Report, No. 10749 Port Don

RIVER TREES Proposed Modification to Rudder. Scale 1" = 1 foot.

S. S. River Tees.

alteration to
existing Rudder
Plate.

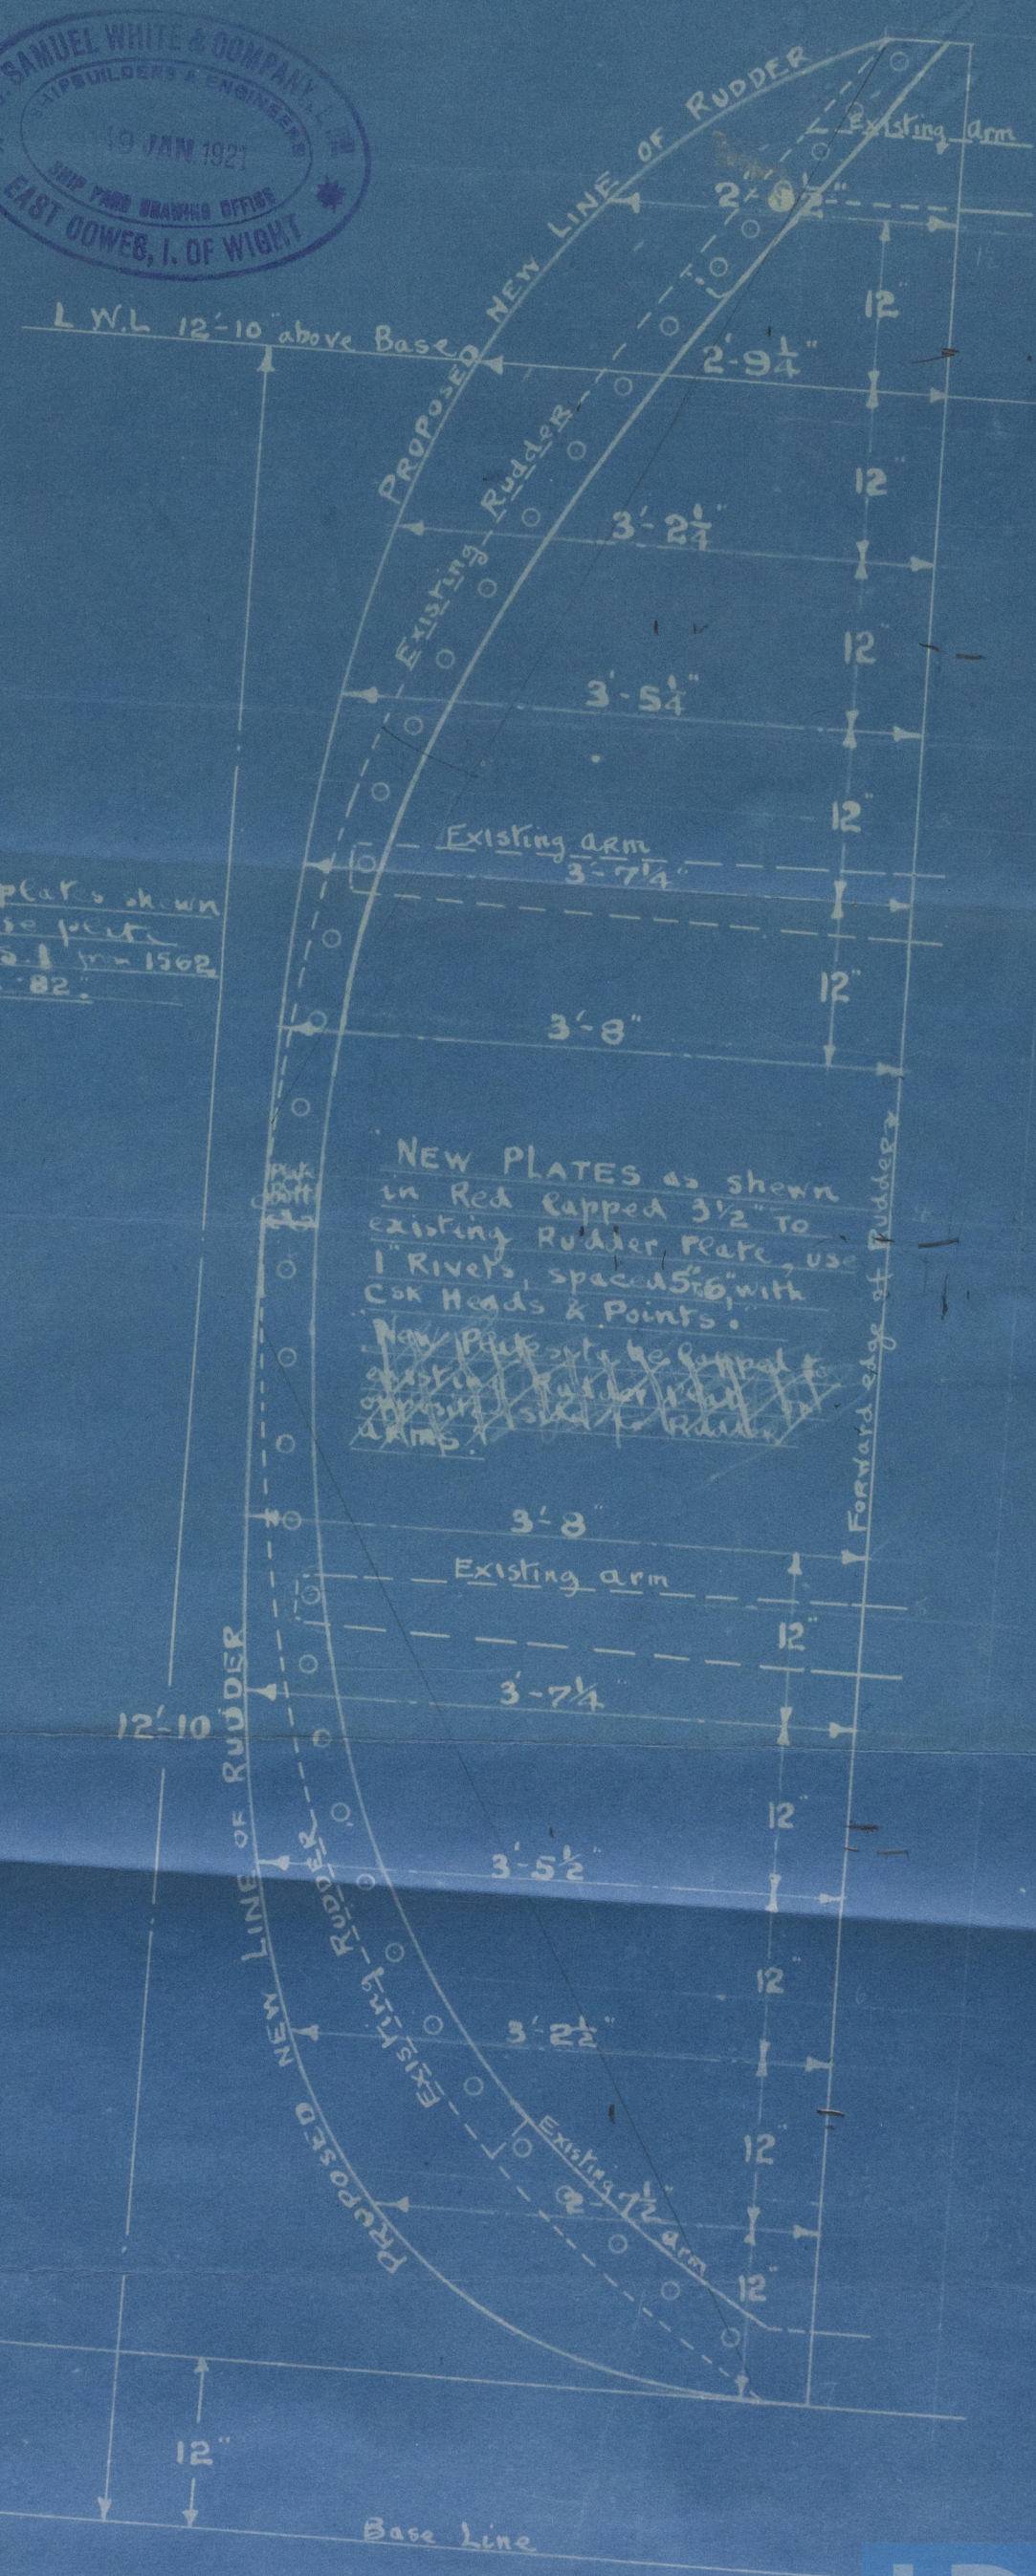
For new plates shown in Red, use plate marked K.S. 1 mm 1562 10'-2 x 17' x 82.

NEW PLATES as shown in Red capped 3 1/2" to existing Rudder plate, use 1" Rivets, spaced 5 1/2" with Cork Heads & Points.
